REF: 02-DOE-00702; 00307-RF-02

Draft Solar Ponds Plume Decision Document Modification May 13, 2002

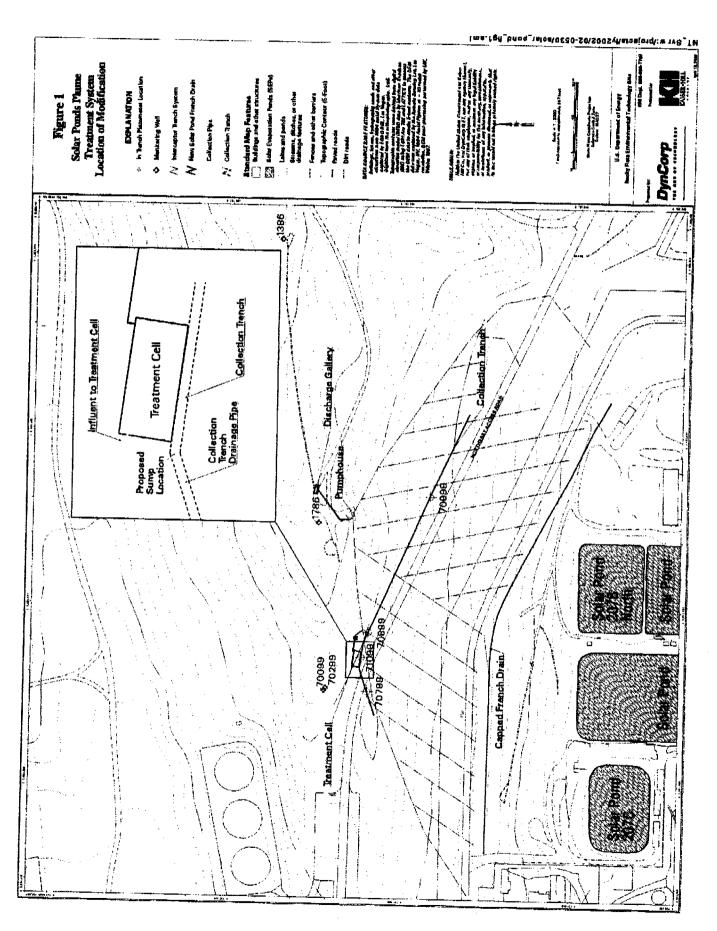
In order to reduce the hydraulic head in the trench and increase the volume of groundwater treated, it is proposed that a sump be placed at the lowest point of the collection trench which is directly in front of the Treatment Cell where water is currently extracted. Figure 1 shows the location of the existing treatment system and where a collection sump would be installed at the low point in the collection trench. The sump will be similar to a domestic water well, and will contain an in-well pump. The sump will be installed away from the geomembrane to keep from damaging it. It is anticipated that the sump will be between 12 and 20 inches in diameter. The sump will be constructed of slotted screen. It will be advanced into the sand lining the trench bottom. The lower portion of the sump will be installed with a drill rig whereas the upper portion will be excavated down to the influent line that feeds the treatment system, approximately fifteen feet in depth. Removed soils will be stored and used for backfill at the end of construction.

Figure 2
Conceptual Drawing of Collection Sump and Solar-Powered Pump

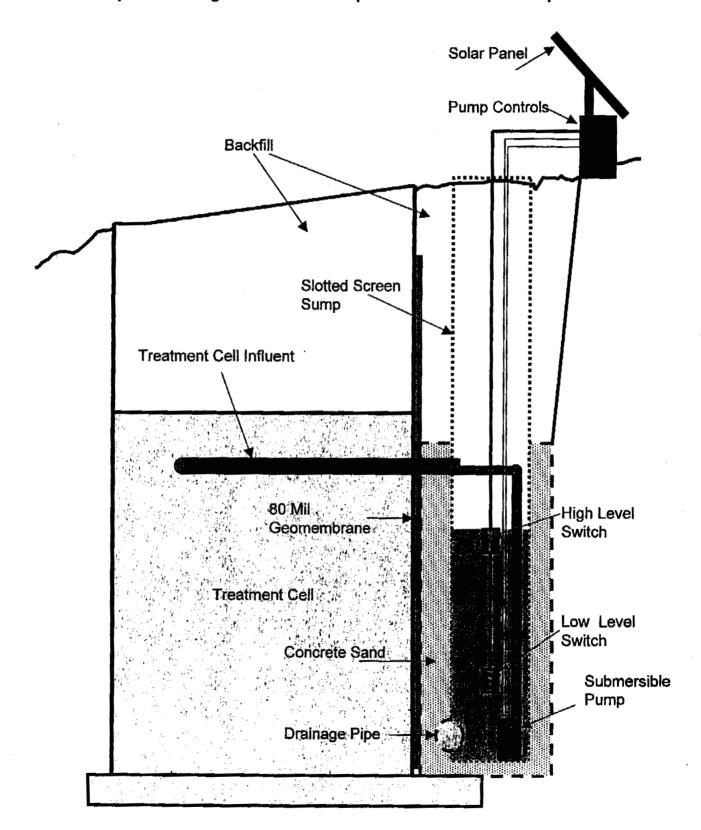
A solar-powered submersible pump will be placed in the sump as shown in Figure 2. The pump discharge line will be constructed of flexible tubing, which will be fed into the treatment cell influent line. The end of the existing treatment cell influent line will be left open in the trench so that, if groundwater rises to the influent line, groundwater can still also gravity flow into the treatment system. The pump will have a maximum capacity of about 5 gallons per minute to keep the pump from cycling excessively. The pump control system will consist of a low level and high level switch, which will maintain the water level in the sump between 20 and 25 feet deep (5 to 10 feet below the existing influent line).
